SUSQUEHANNA STEAM ELECTRIC STATION
NRC INSPECTION REPORT 50-388/84-12
NOTICE OF DEVIATION
ER 100508 FILE 841-04
PLA-2221

RESPONSE TO NOTICE OF DEVIATION

DEVIATION (388/84-12-02)

ATTACHMENT 2

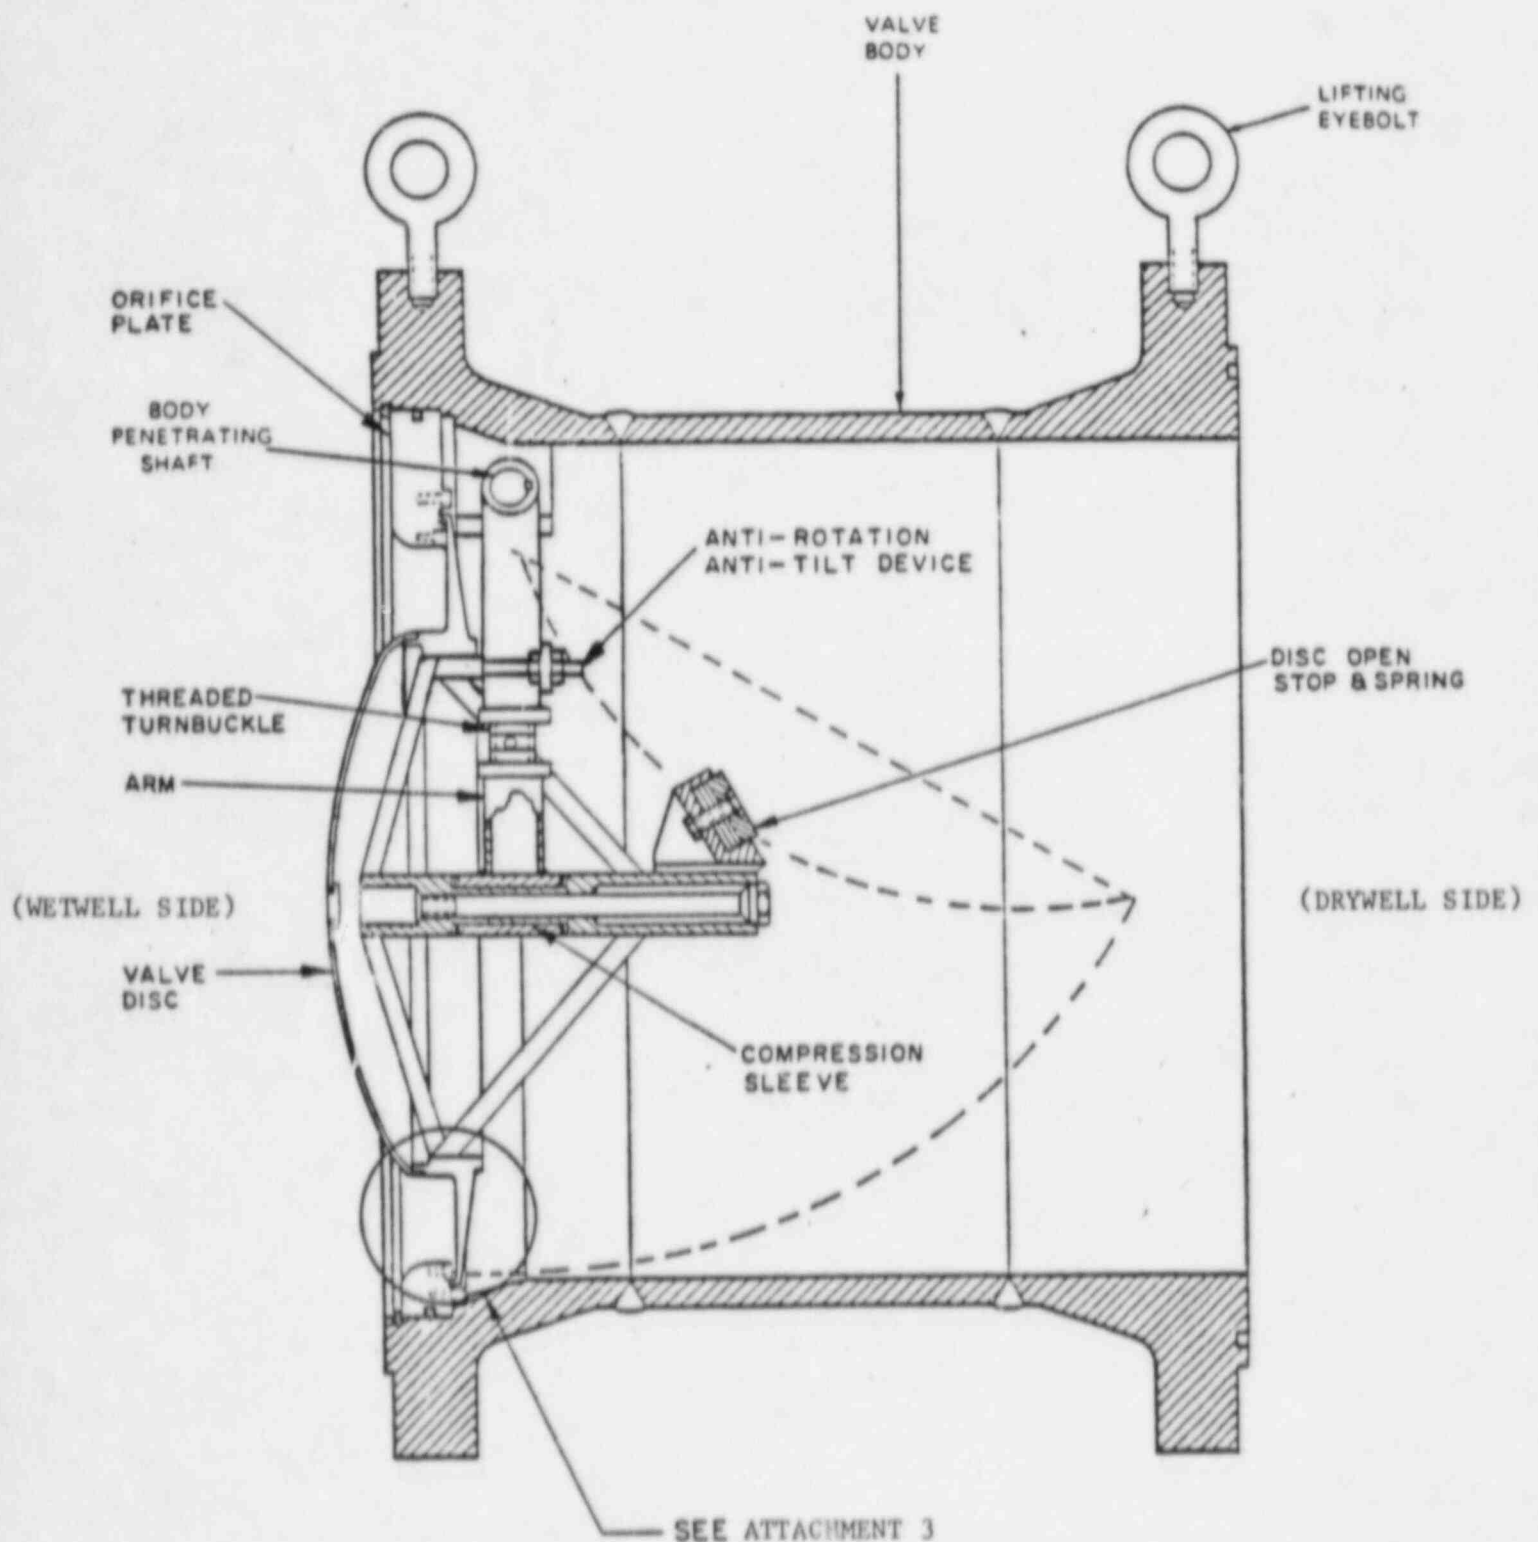
The position indicating switches are operated through a mechanical linkage external to the valve body that is connected to the body penetrating shaft (see Attachment 2) which rotates as the valve disk opens or closes. Disk movement is transmitted through the mechanical linkage to the position indicating switches. The switches complete an electrical connection to a remote indicator which provides a visual indication that the valve is closed. When the valve disk reaches the full open position a rotary switch is actuated which provides remote visual indication that the valve is open. Hysteresis exists in the mechanical linkage and the switches. Wherever possible, hysteresis is minimized, but its exact value is not established nor is it constant (due to manufacturing tolerances, mechanical wear, and thermal growth). The position indication switches provide nominal indications of valve disk position (open or closed) above the hysteresis tolerance.

ATTACHMENT 3

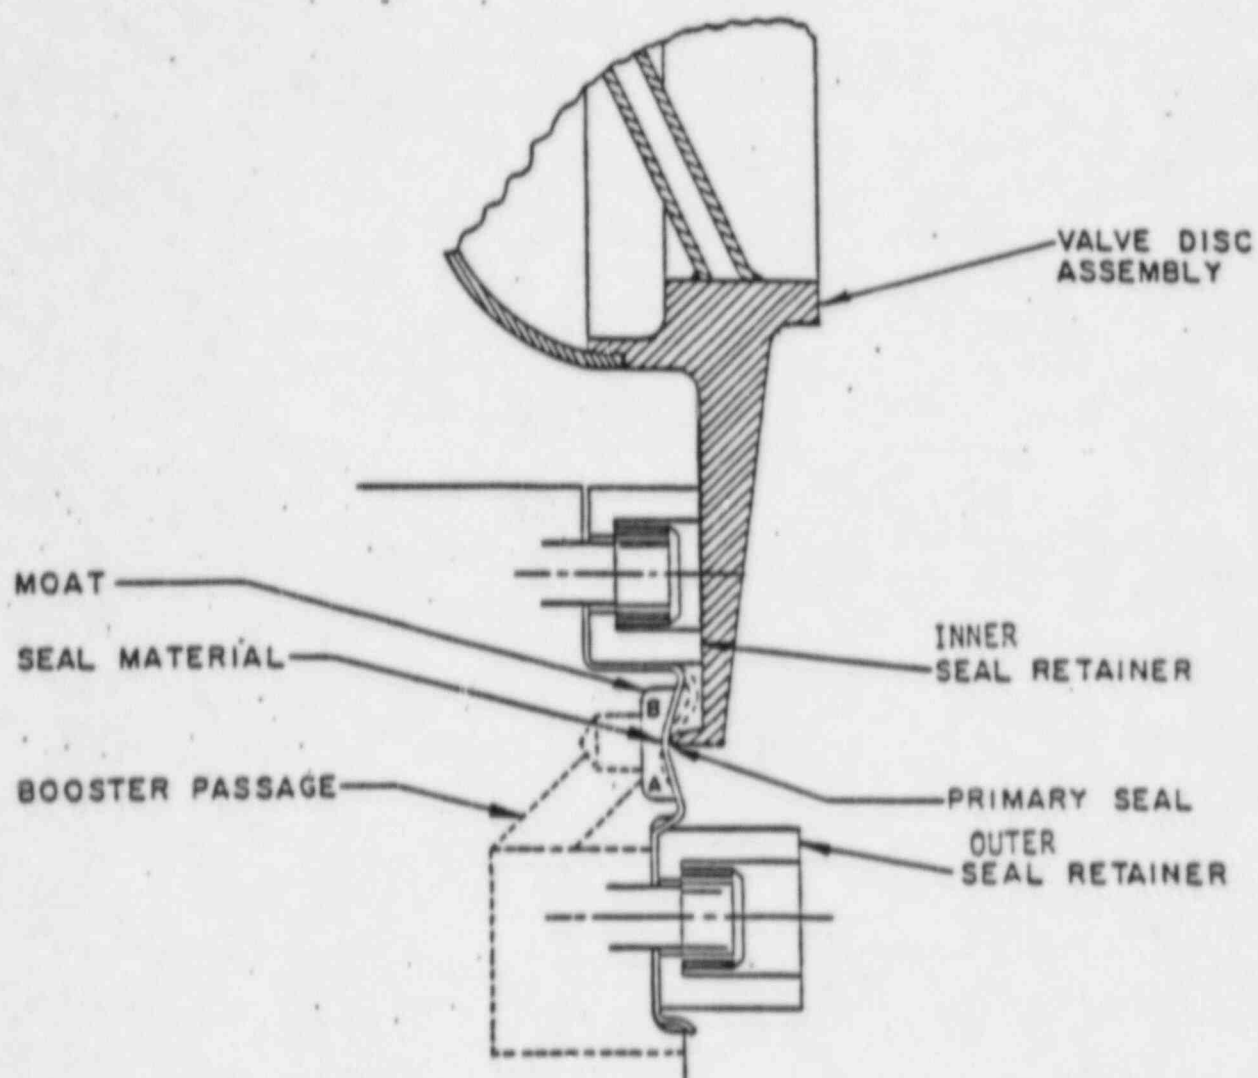
The patented seal design is illustrated in a cutaway view included as Attachment 3. An elastomer diaphragm is stretched over a moat which encircles the valve seat. The diaphragm is held in place by two concentric retainer rings. The valve seals when the seal lip on the valve disk assembly touches the diaphragm. The inner seal retainer ring serves to limit the penetration

of the lip into the seal from 0.010 to about 0.020 inches. The primary seal between the lip and diaphragm is pressure boosted. Pressure from the wetwell side of the vacuum breaker is fed into the moat under the elastomer diaphragm. This results in a zero pressure difference across the seal at point A and a full pressure difference across the seal at point B thus assuring a firm contact between the disk and seat. The vacuum breakers are equipped with an anti-tilt, anti-rotation clamp device. This device assures that the disk remains centered and aligned with the valve seat once the initial adjustments are completed. Once adjusted, the valve disk alignment should be adequate for the life of the vacuum breaker. In addition, the device will prevent misalignment during the monthly vacuum breaker operability tests required by Technical Specification section 4.6.4b.2. As a result of the above, it can be seen that the valve is designed to form and maintain a reliable, positive seal under normal and accident conditions.
